# Revised wishbone bush - Opel / Vauxhall Corsa / Combo

SSTB 0007

## FCA6026/7 & FCA7043/4 FSK6109 & FSK7646

New version (swaged bush)

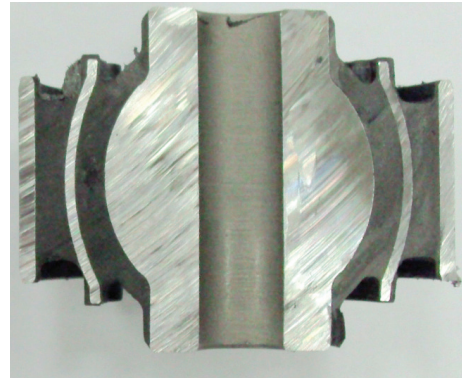
Following on from changes made by the Vehicle Manufacturer, First Line has superseded wishbones FCA6026 and FCA6027 to FCA7043 and FCA7044 and the corresponding wishbone bush FSK6109 to FSK7646 respectively.

The Original Equipment specification of the rear wishbone bush has been upgraded with enhancements to its construction. The bush now has a swaged design to further improve its service life.

The swaged bush provides a greater bonding area for the rubber, which directly increases the overall longevity.
